Planning Decisions Committee

6.30pm, Tuesday 2 May 2023

Item		Page	Rec. Page
6.1	PLN22/0679 - 10 - 32 Duke Street, Abbotsford - Buildings and works associated with the construction three buildings (up to eight storeys plus roof plant) for the purpose of office and food and drink premises (cafés) and a reduction in car parking requirement of the Yarra Planning Scheme.	5	52

1. This report provides Council with an assessment of planning application PLN22/0679 which relates to land at No.10 – 32 Duke Street, in Abbotsford. The report recommends approval subject to conditions.

Figure 18. Urban Design Plan Mark-up Plan provided by Council’s Urban Design Unit.

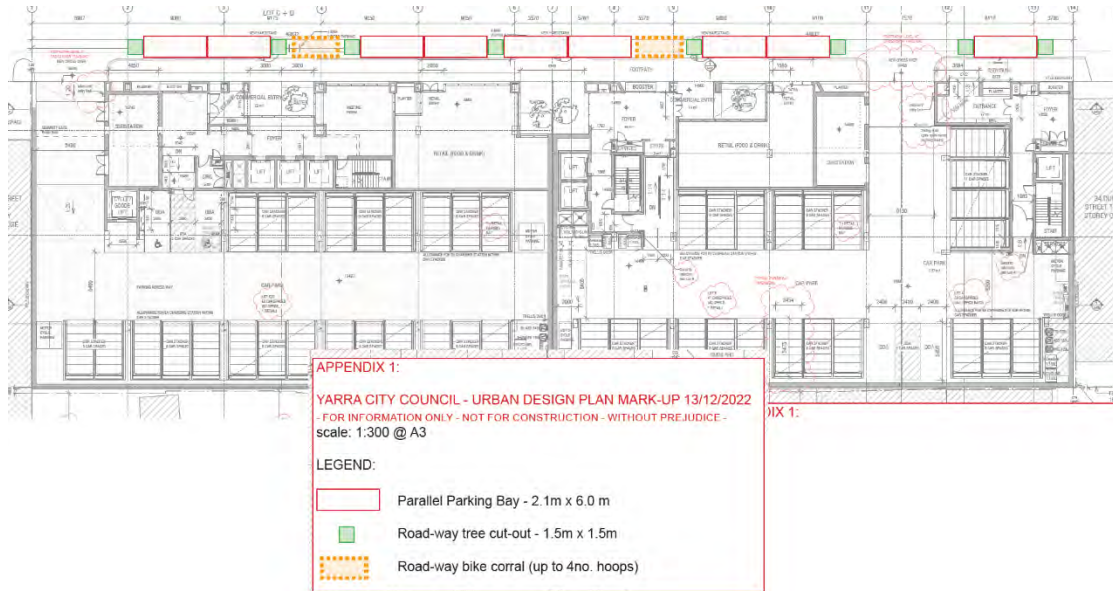
152. Council’s Urban Design Unit were generally supportive of the proposal but raised concerns with the proposed kerb outstands due to drainage implications, and with the quantity of the street trees citing these as inadequate for the length of the development’s frontage. Council’s Urban Design Unit have indicated potential for up to 8 street trees (with road-way cut-outs), combined with parallel parking spaces and bicycle coral spaces. To inform their proposal, their advice was accompanied by an appendix that marked this up as shown at Figure 18 below:
